Informal document **GRSP-51-36-Rev.1**
(51st GRSP, 20 – 25 May 2012,
agenda item 14)

Regulation No. 44 (Child Restraint Systems)

Proposal for Supplement 6 to the 04 series of amendments

Submitted by the expert from France*

Figure 4a

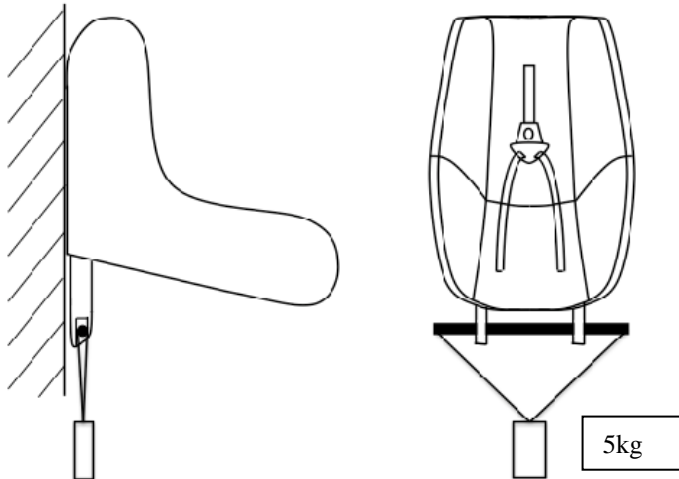
- "8.2.9. The complete seat, or the component fitted with ISOFIX attachments (e.g. ISOFIX base) if it has a release button, is attached rigidly to a test rig in such a way that ISOFIX connectors are vertically aligned as shown in Figure 4a. A 6 mm diameter bar, 350 mm long, shall be attached to the ISOFIX connectors. A mass of 5 kg shall be attached to the extremities of the bar.**
